**California High-Speed Rail Authority**

**Request for Proposal for Design-Build  
Services for Construction Package 4**

**Reference Material, Part E.11 – Master  
Streambed Alteration Agreement for  
Construction Package 1C**

Subject: Amendment No. 2 of Master Streambed Alteration Agreement  
 Notification No. 1600-2013-0060-R4

**Figure 1**  
 Department of Fish and Wildlife  
 Conservation Planning GIS  
 Central Region  
 Date: 6/12/2015

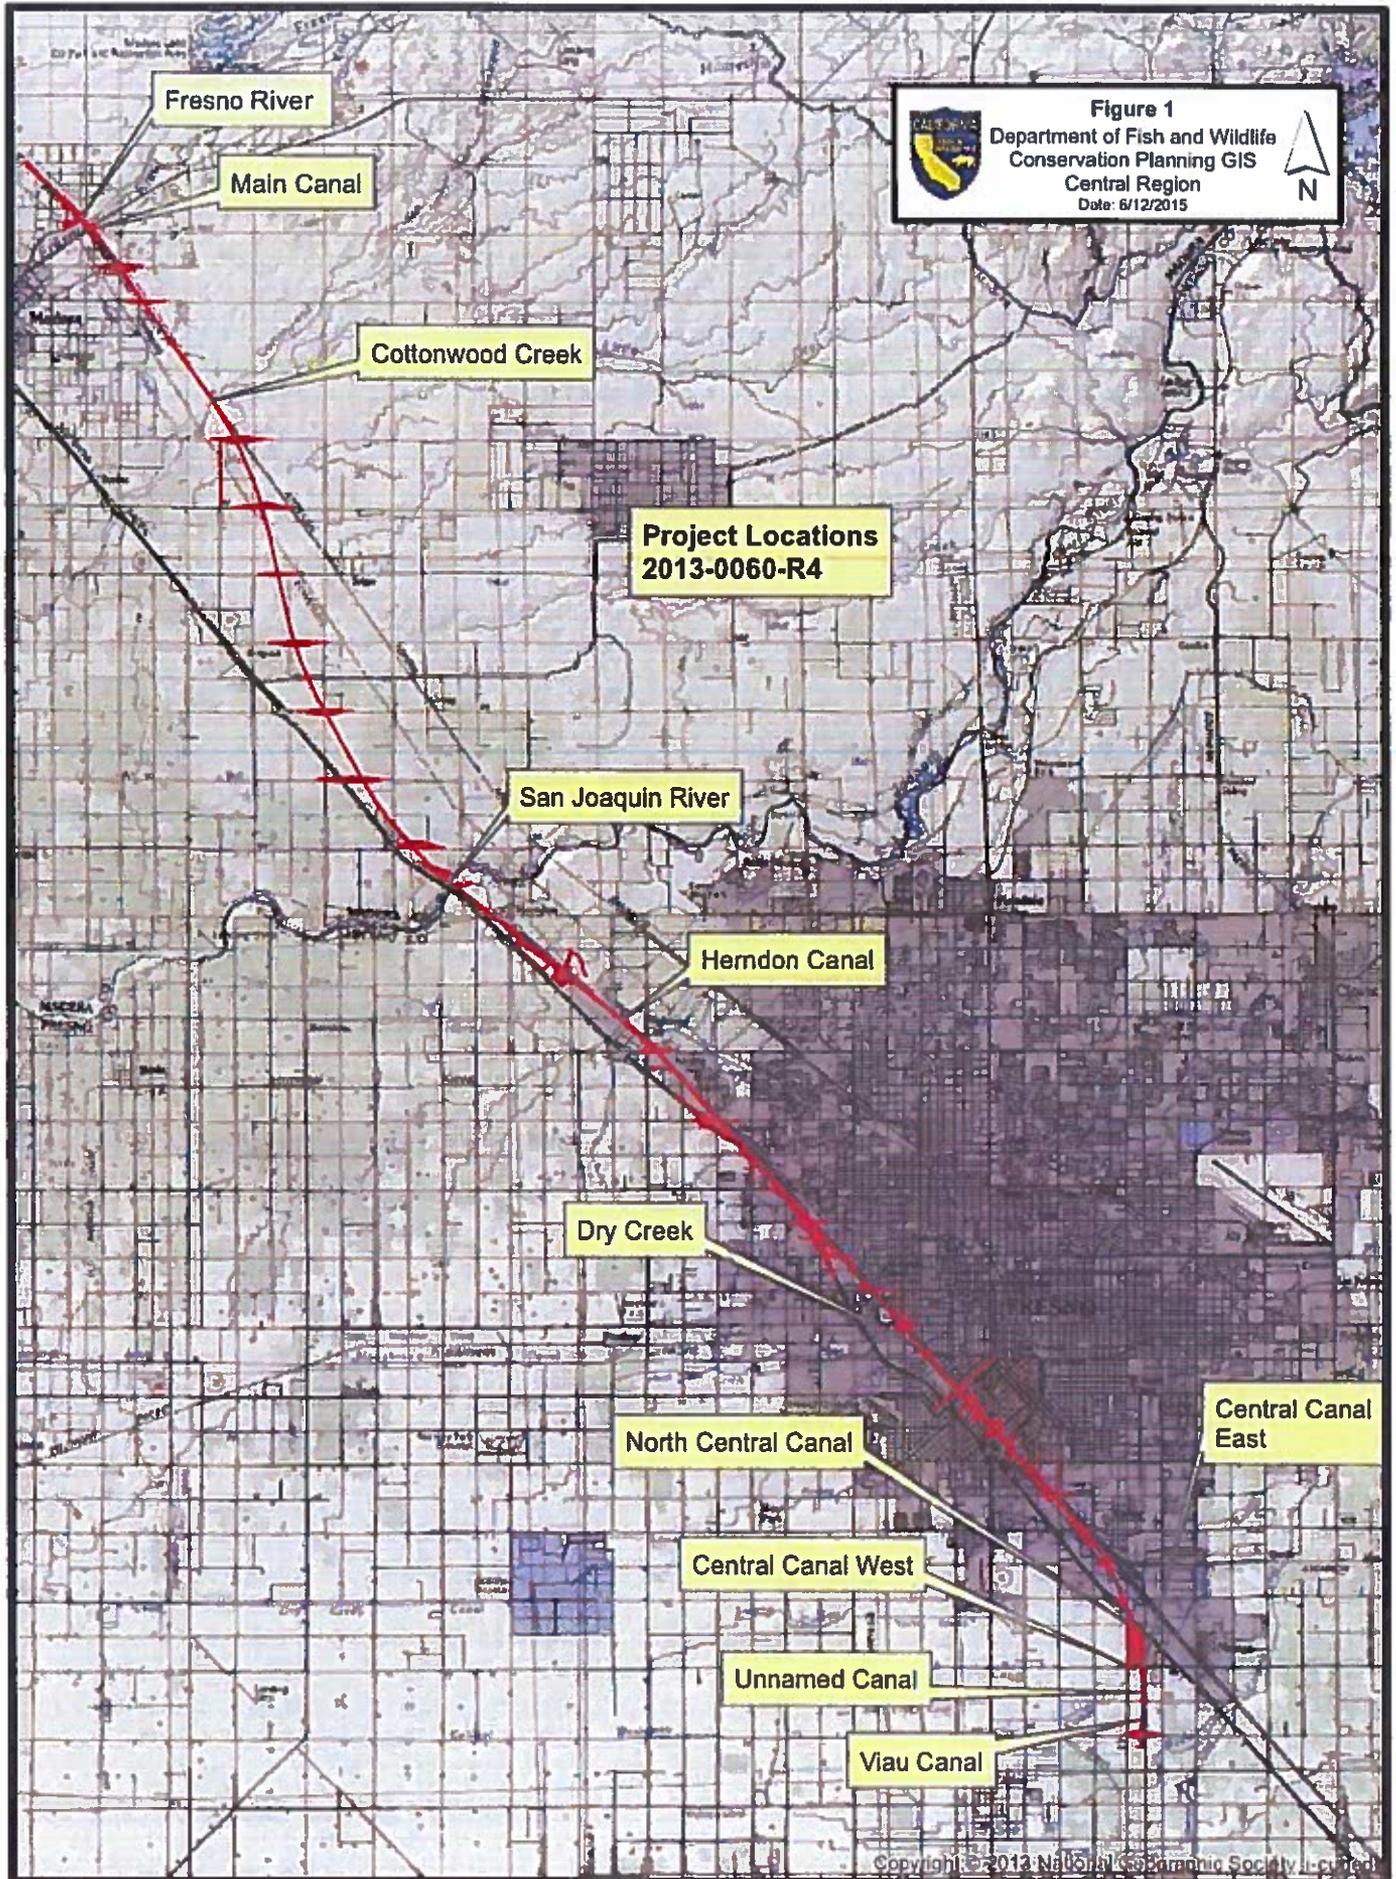
13. Replace Figure 1 of the Agreement with the revised Figure 1 that is Exhibit A to this amendment, showing the combined construction footprint for Permitting Phase 1 of the Merced to Fresno section and the CP1C Permitting Phase 1 of the Fresno to Bakersfield section HST.

# Figure 8

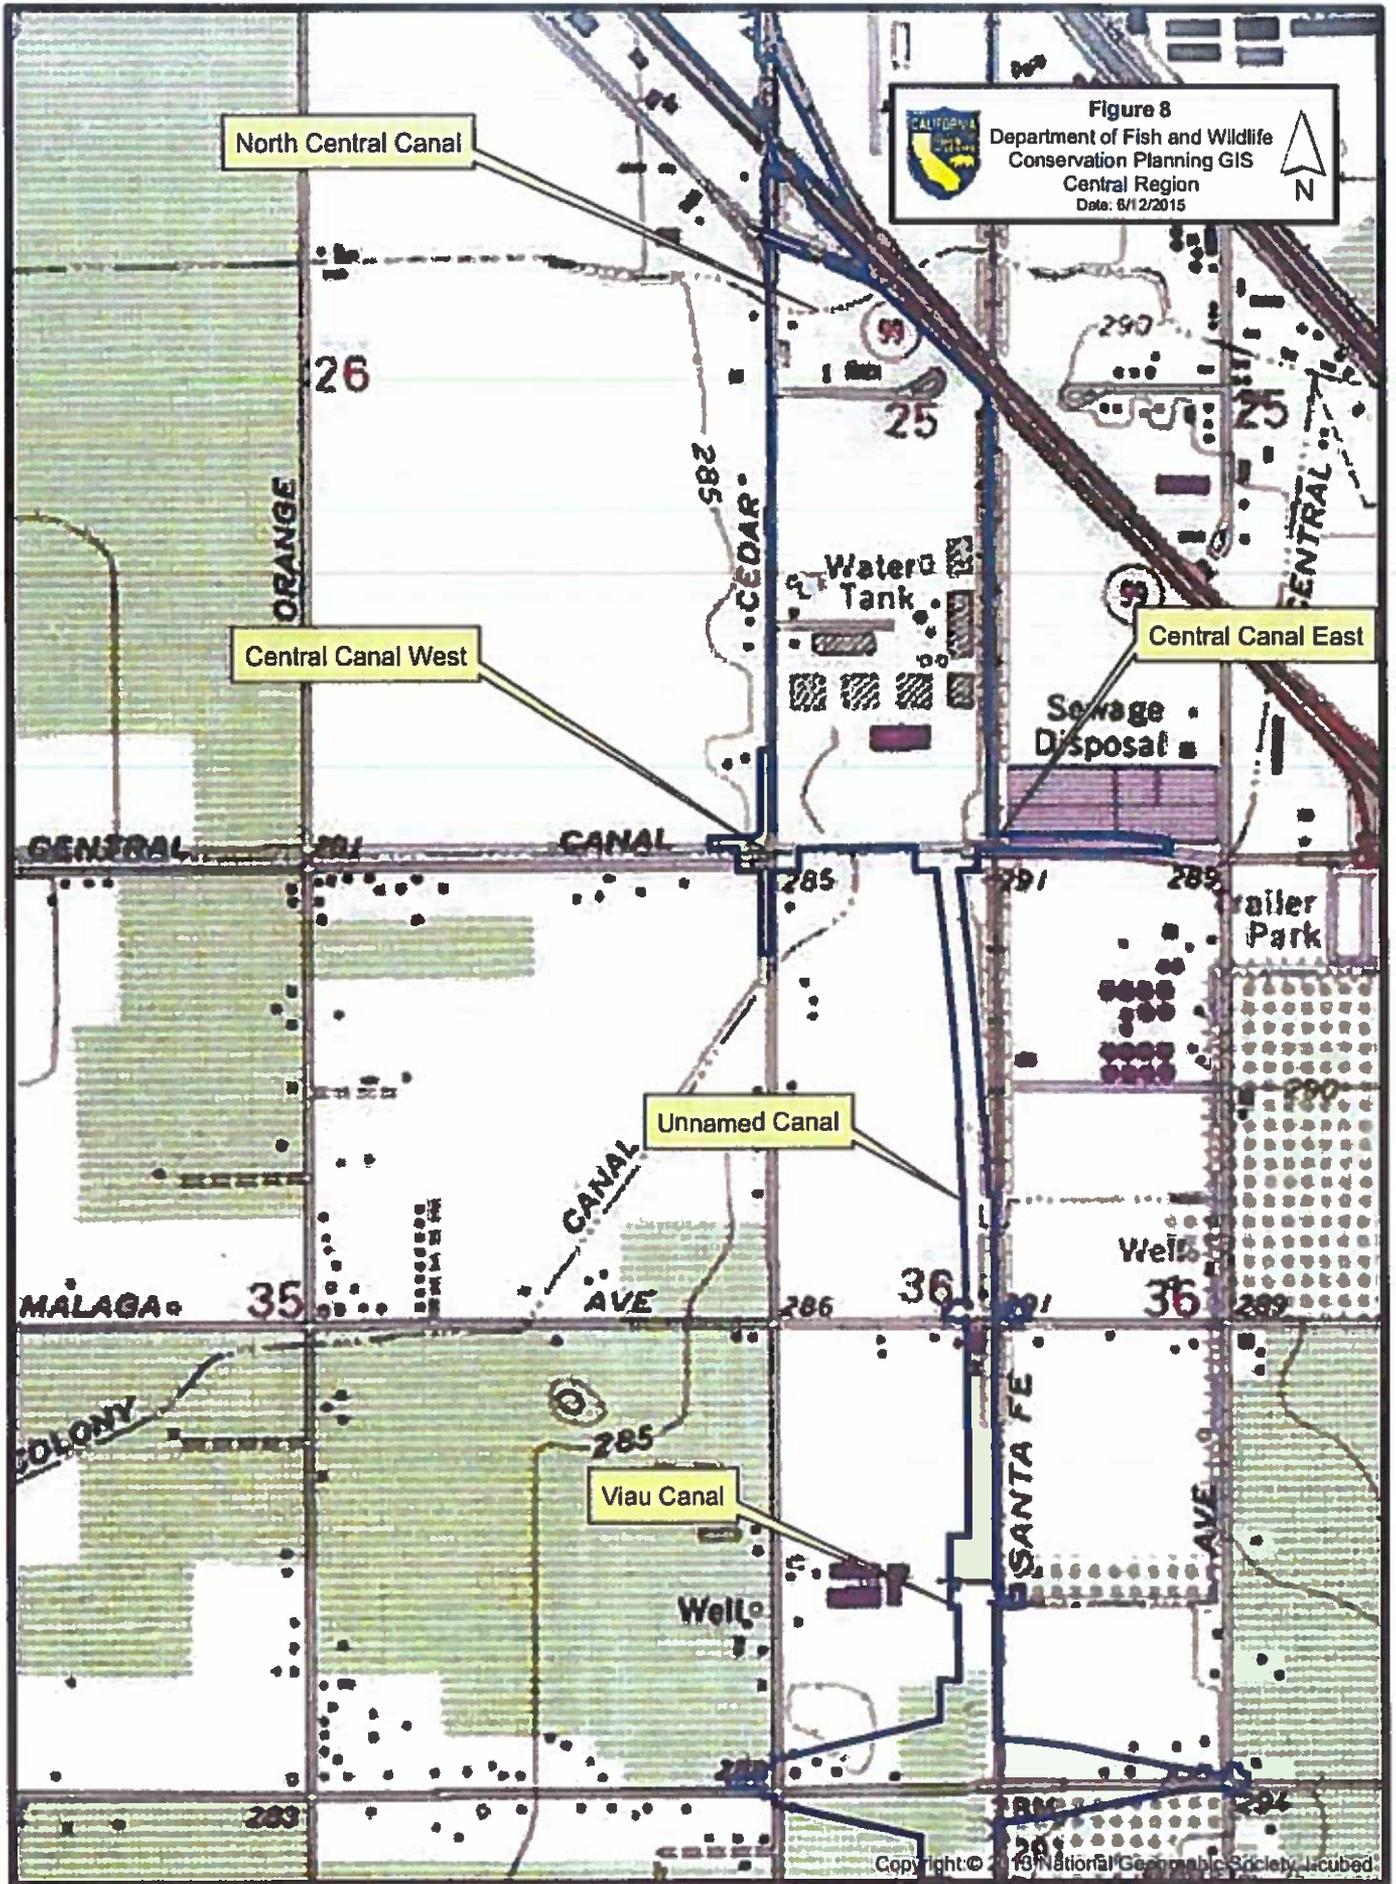
14. Add Figure 8 to the Agreement, included as Exhibit B to this amendment, showing the Construction Footprint for crossings at North Central Canal, Central Canal West, Central Canal East, Unnamed Canal, and Viau Canal.
